HIAL Consultation Report

Proposal for the Introduction of Controlled Airspace and Optimisation of Instrument Flight Procedures at Inverness Airport

Consultation Report

Release Date: 10th August 2015

Figure 4 The Consulted Inverness Airport CTR and CTAs. Ordnance Survey Digital Data © Crown Copyright 2014, Licence 0100031673

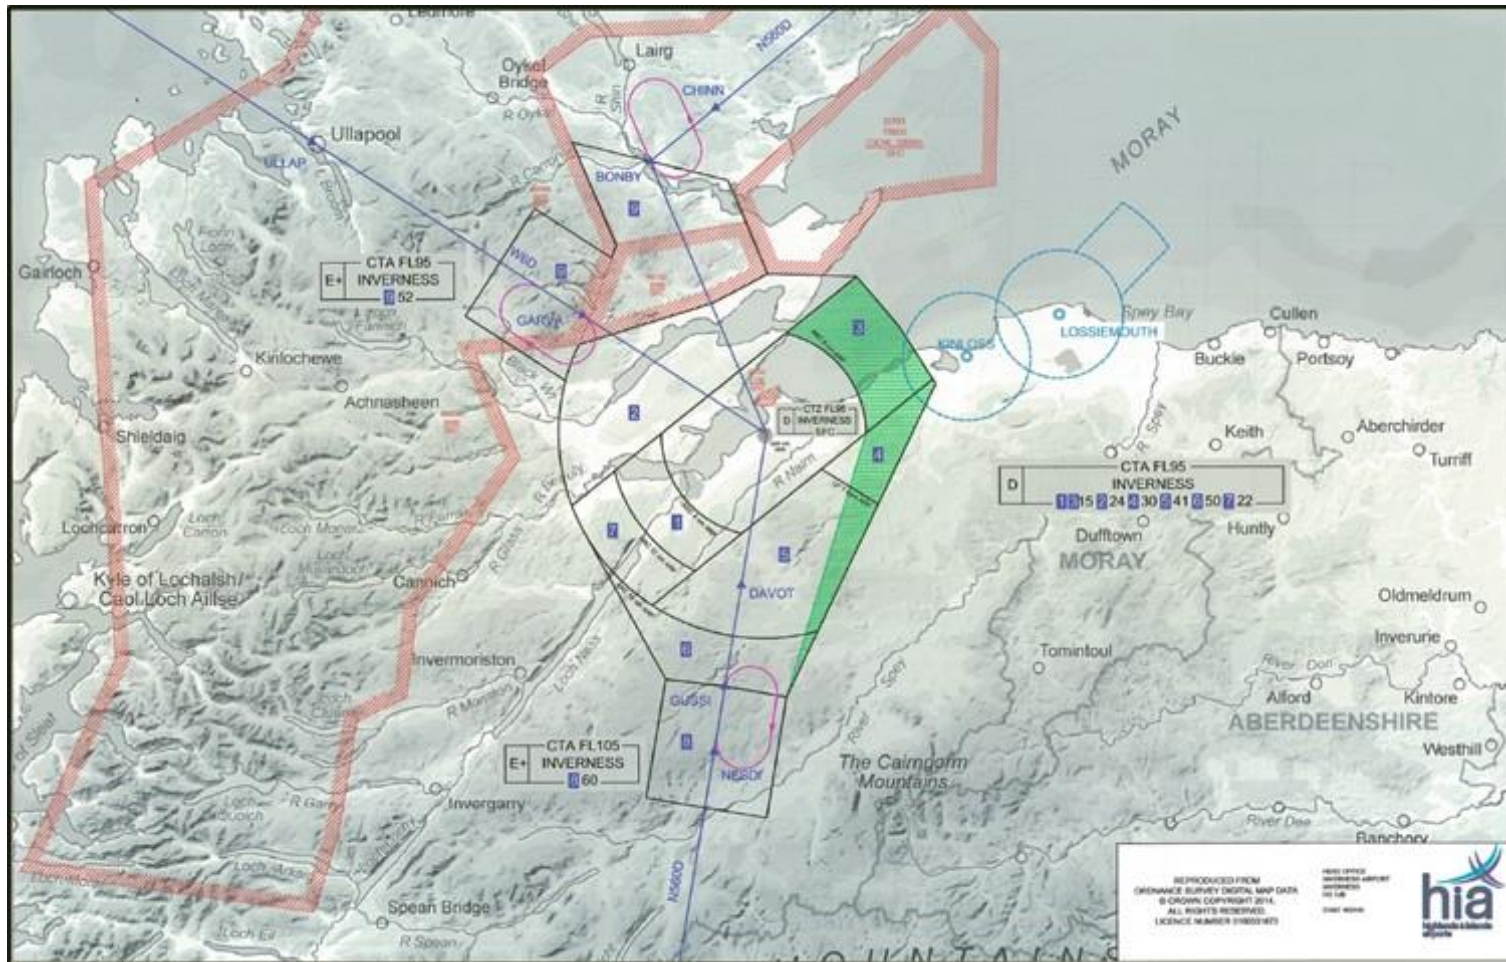
| CTA Reference | Nature of Issue | Number of Consultees who Raised Issue | HIAL Proposed Solution or Redesign |
|---------------|---|---------------------------------------|--|
| CTA-8 | Concern on the introduction of CTA-8 – all flights to the West and Northwest will become impractical and access permanently lost | 1 | The objector proposed that CTA-8 is modified to avoid populated areas/National Park. However, it appears that the objector did not understand that Commercial Air Traffic (CAT) operating in and out of Inverness Airport currently use that airspace to access airway N560. The Airspace Classification of CTA-8 is Class E+TMZ. |

The MOD objects to the current Inverness ACP; it questions the requirement for CTA-2 and CTA-9 given the scale of commercial operations utilising the associated Class E airways structure.

| 13 | Concern on the introduction of CTA-8 to the already controversial CTA-6. Common to all 3 gliding clubs in the Highlands area (Aboyne (Deeside), Elgin (Highland) and Kingussie (Cairngorm)); effectively all flights to the west and northwest will become impractical and access permanently lost to some of the best soaring in the UK. Proposed Solution: CTA-8 location modified to avoid populated areas/ National Park. Despite requests, no indication received of how the CAS will affect the GUSSIE box LoA between the above | A change of airspace classification for CTA-6 to Class E+TMZ will mitigate base of CAS and access concerns near Feshiebridge aerodrome for VFR operators with a transponder and/or radio. The initial request for information with regard to the GUSSI Box LoA was made prior to the final document had been endorsed and signed by all three parties to the LoA (NATS, Inverness Airport ATC & the BGA). An amendment to the current 'GUSSI Box' NATS, Inverness & BGA LoA will further facilitate glider operations in CTA- |

| <p>18</p> | <p>Concern regarding CTA-8 and its proposed base of 6,000 ft amsl - only a small proportion of gliders are equipped with transponders and the VHF transmission range will be near or beyond its useful range (6,000 ft or less, around 30 miles and mountainous terrain), so most glider pilots will have difficulty contacting Inverness ATC for clearance to enter CTA-8. Consideration could be given to at least raising the base level in this area.</p> | <p>A change of airspace classification for CTA-6 to Class E+TMZ, and the current classification (Class E+TMZ) will mitigate base of CAS and access concerns near Feshiebridge aerodrome for VFR operators with a transponder and/or radio. An amendment to the current 'GUSSE Box' NATS, Inverness & BGA LoA will further facilitate glider operations in CTA-8. The base altitudes of CTAs-6 and 8 will be under continuous review.</p> |

| 21 | Concerns raised over low base of southern CAS, restricting the soaring area west of Aviemore and north of Kingussie. Suggests the control area down to 4,500 ft (about 3,700 ft above the airstrip) near Kingussie is completely unnecessary, restricting GA operations and infringing Cairngorm's soaring area to the west. | A change of airspace classification for CTA-6 to Class E+TMZ, and the current classification (Class E+TMZ) will mitigate base of CAS and access concerns near Aviemore and Kingussie for VFR operators with a transponder and/or radio. An amendment to the current 'GUSSI Box' NATS, Inverness & BGA LoA will further facilitate glider operations in CTA-8. The base altitudes of CTAs-6 and 8 will be under continuous review. |
| 24 | Outraged at proposal to lower flight level to 6,000 ft to enable holding pattern above Kingussie and Newtonmore (not represented on Figure 1). Proposed Solution: airway moved 10 miles west to | Airway N560 and the GUSSI Hold already exist. Neither are part of this consultation and CAT already use these procedures and have |

A change of airspace classification for CTA-2 to Class E+TMZ will mitigate base of CAS concerns near Knockbain airstrip and over the Black Isle for VFR operators with a transponder and/or radio. Those with radio only would need to call Inverness ATC relaying their intentions and to build information on any military traffic entering or exiting Tain Range.

A change of airspace classification for CTA-6 to Class E+TMZ will mitigate base of CAS and access concerns near Feshiebridge aerodrome for VFR operators with a transponder, or radio where not equipped with a transponder. An amendment to the
